MEMORANDUM DATE: October 6, 2021

RE: **220 South L Street**

TITLE: HRPB Project Number 21-00100269: A Certificate of Appropriateness (COA) for window and door replacement for the property located at 220 South L Street; PCN #38-43-44-21-15-091-0070. The subject property is located in the Low-Density Multi-Family Residential (MF-20) zoning district and is a contributing resource to the Southeast Lucerne Local Historic District.

Existing Window and Door Replacement
 North Elevation

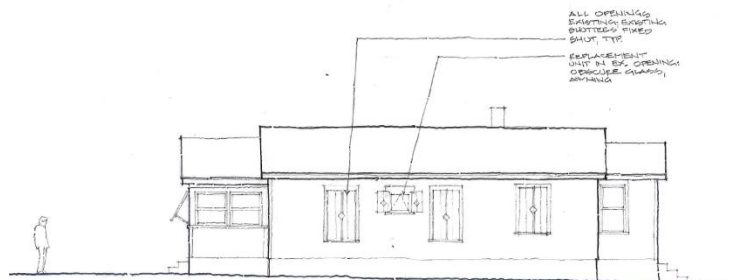
- North Elevation
 - Removal of one window opening to be replaced with siding
 - Alteration of one window opening to accommodate a pair of windows

Proposed Window and Door Replacement
 South Elevation

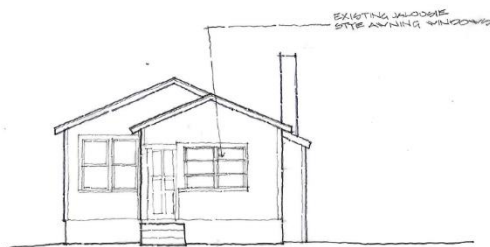
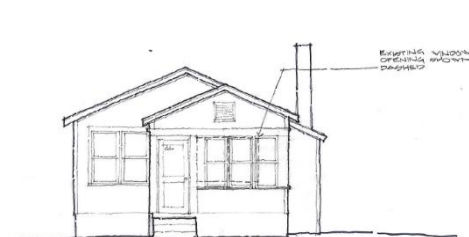
As part of this application, window openings on the south elevation will be enclosed due to the non-conforming side setback and insufficient separation from the neighboring structure. The proposed window and door replacement does not increase the existing non-conforming setbacks and seeks to improve safety.

- South Elevation:
 - Removal of three window openings to be replaced with faux shuttered openings

- 8) The faux shuttered openings shall conform to the original opening sizes, shall be recessed, and shall utilize the structure’s original wood shutters. If the wood shutters are too deteriorated for continued use, they shall be replaced in-kind, subject to staff review at permitting.
